### Threaded connection for temperature sensor may have to be closed with screw plug

**BTS reference:** T915699      **BTS-Service-Set-Nr:** T981436

screw-plug  
A 001 990 0617

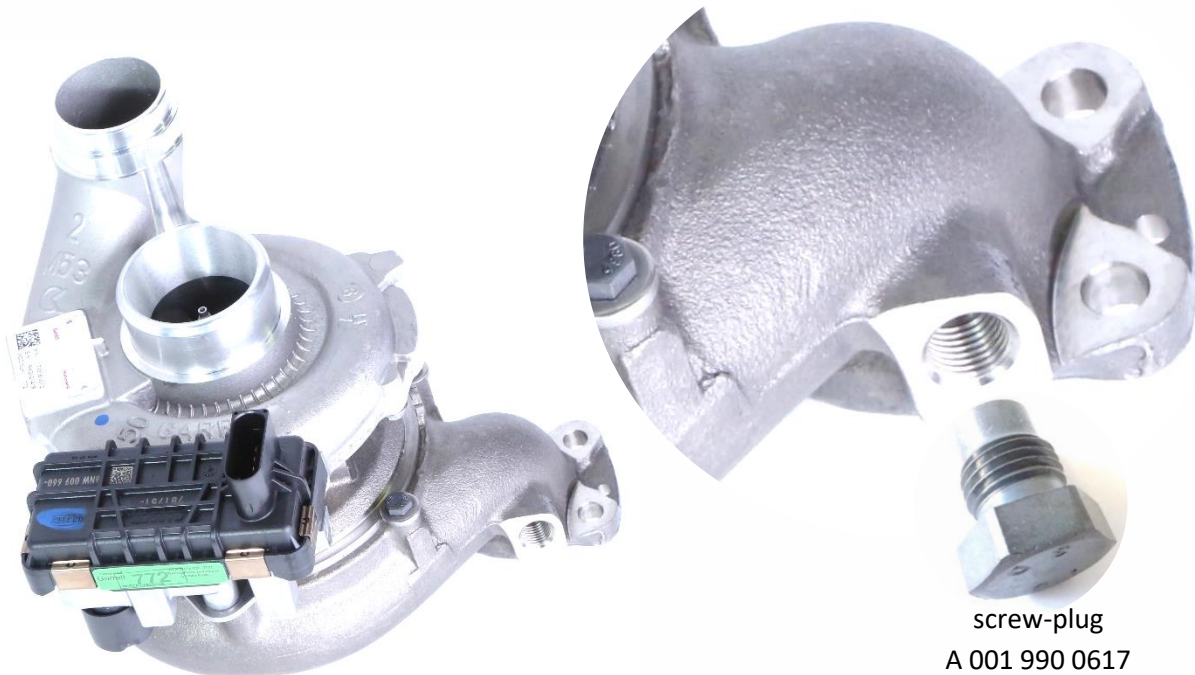
The previous design numbers 764381-xxxx, 764809-xxxx and 781743-xxxx of the turbocharger manufacturer were replaced by the current execution number **777318-5002S**.

This turbocharger differs from the older version by a threaded connection in the turbine inlet for a temperature sensor. On vehicles without a temperature sensor, the threaded connection is closed with a screw plug.

If necessary, the threaded connection for the missing temperature sensor must be professionally closed with a screw plug with the Mercedes part number A 001 990 0617.
